FINAL EXPRESS TERMS
FOR
PROPOSED BUILDING STANDARDS
OF THE
DEPARTMENT OF HOUSING AND COMMUNITY DEVELOPMENT
REGARDING AMENDMENTS TO THE 2010 CALIFORNIA BUILDING CODE
CALIFORNIA CODE OF REGULATIONS, TITLE 24, PART 2, CHAPTER 11A ONLY
(HCD 02/10)

The Department of Housing and Community Development (HCD) proposes to make necessary changes to the 2010 edition of the California Building Code (CBC), Chapter 11A – Housing Accessibility, as presented on the following pages.

14. HCD proposes to amend Division VII – FIGURES as follows:

FIGURE 11A-1B— HEADROOM CLEARANCE AND OVERHANGING OBSTRUCTION

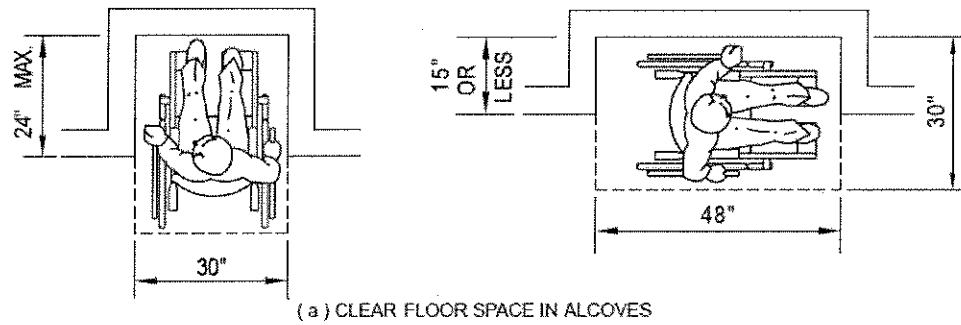
FIGURE 11A-1B – OVERHANGING OBSTRUCTION

Amend title to read "Headroom Clearance and Overhanging Obstruction".
Correct the dimension of "Overhanging Obstruction": Delete 84" and replace with 80".
Add dimension (84") for "Headroom Clearance".
Indicate the location of measurements for "Overhanging Obstruction" and "Headroom Clearance".

FIGURE 11A-1H—MINIMUM CLEAR FLOOR SPACE FOR WHEELCHAIRS

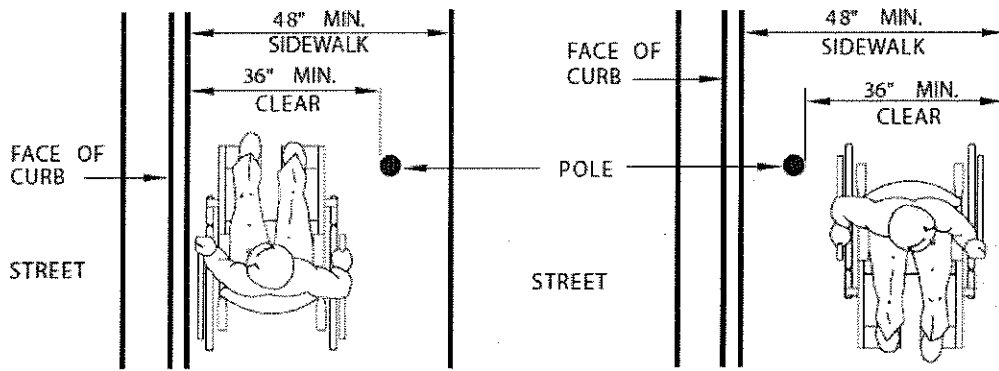
FIGURE 11A-1H – MINIMUM CLEAR FLOOR SPACE FOR WHEELCHAIRS

Delete "24" or more" and replace with "greater than 24".

FIGURE 11A-5A—RAMPS AND SIDEWALKS

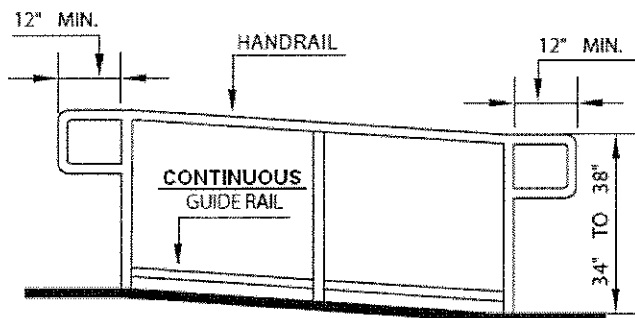
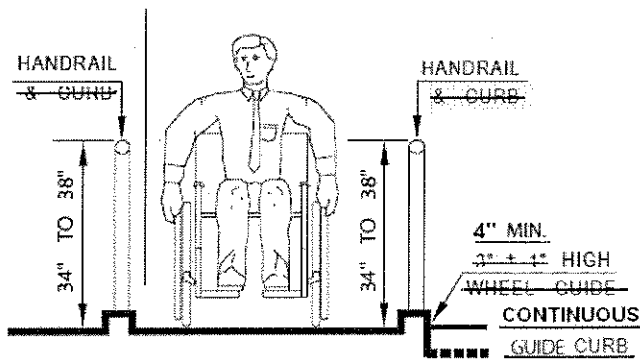
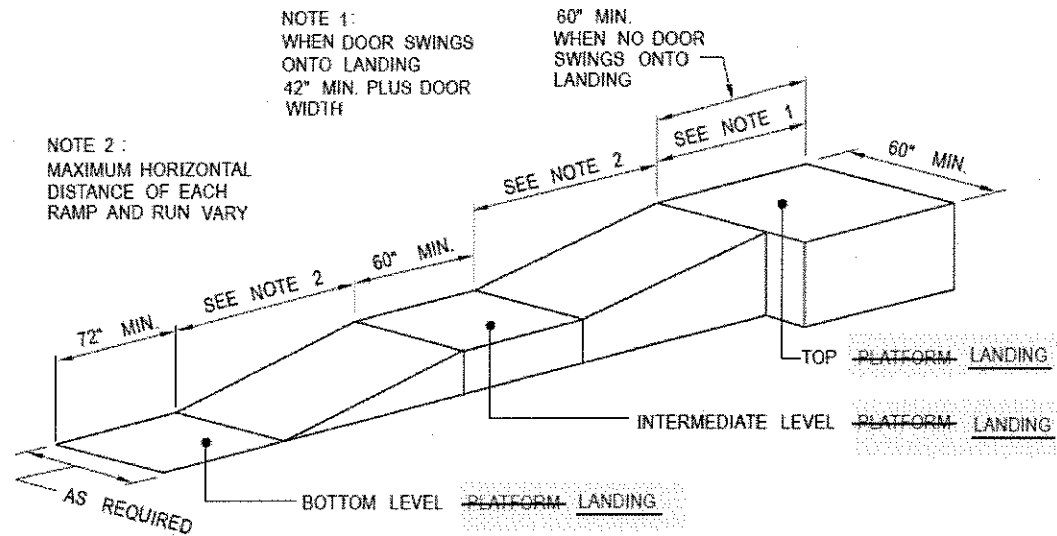
FIGURE 11A-5A – RAMPS AND SIDEWALKS

Diagram (b):

Amend title to read "Handrail and Guide Rail";
Indicate location of handrail and guide rail;
On the Guide Rail Detail, delete Guide Rail centered at $3" \pm 1"$ and replace with $<4"$.

Diagram (c):

Amend title to read "Guide Curb";
Delete "& Curb" below "Handrail" on both sides of wheelchair;
Delete $3" \pm 1"$ and replace with 4" min.;
Delete "Wheel Guide" and replace with "Guide Curb";
Delete "Wheel Guide Detail" and replace with "Guide Curb Detail".

FIGURE 11A-6C—RAMP DIMENSIONS

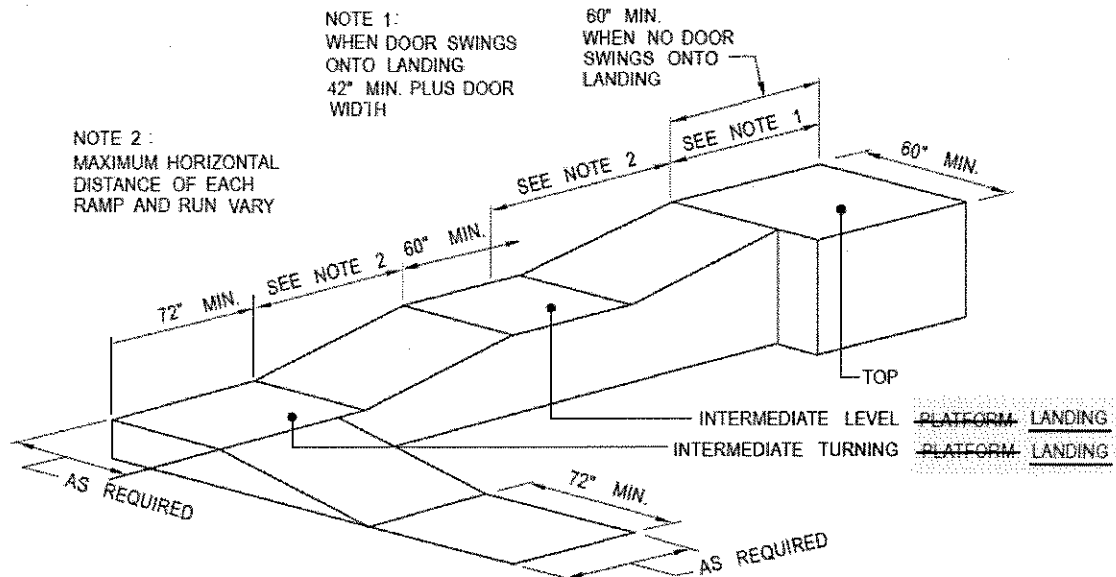
FIGURE 11A-6C – RAMP DIMENSIONS

Delete "platform" and replace with "landing".

FIGURE 11A-6D—RAMP LANDING AND DOORWAY

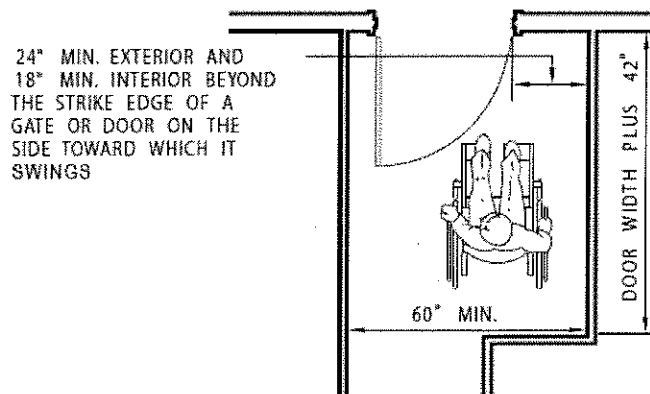
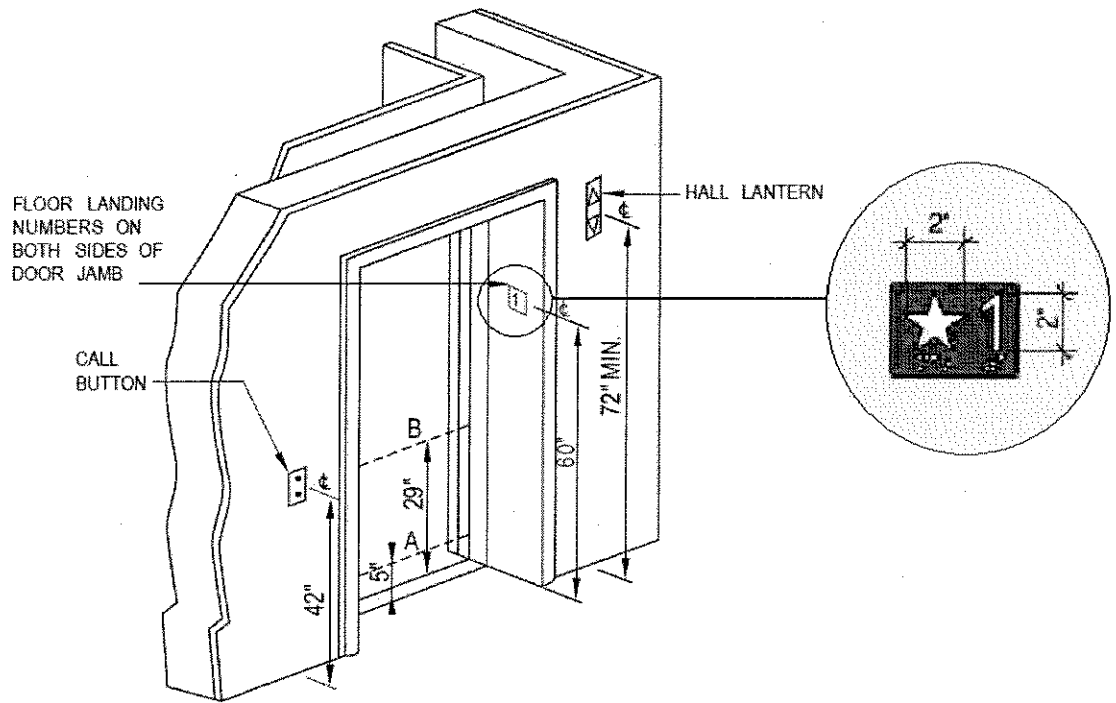
FIGURE 11A-6D – RAMP LANDING AND DOORWAY

Delete "platform" and replace with "landing".

FIGURE 11A-7C—HOISTWAY AND ELEVATOR ENTRANCES

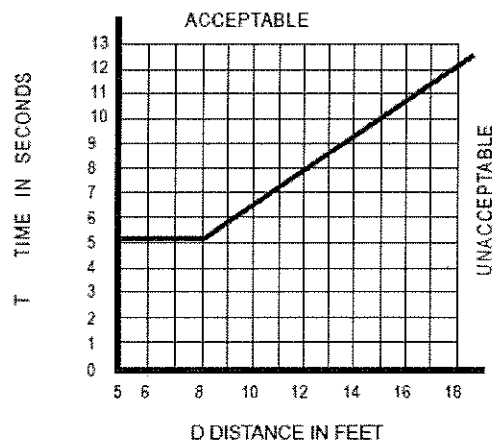
FIGURE 11A-7C – HOISTWAY AND ELEVATOR ENTRANCES

Include enlarged diagram of the floor designation sign.
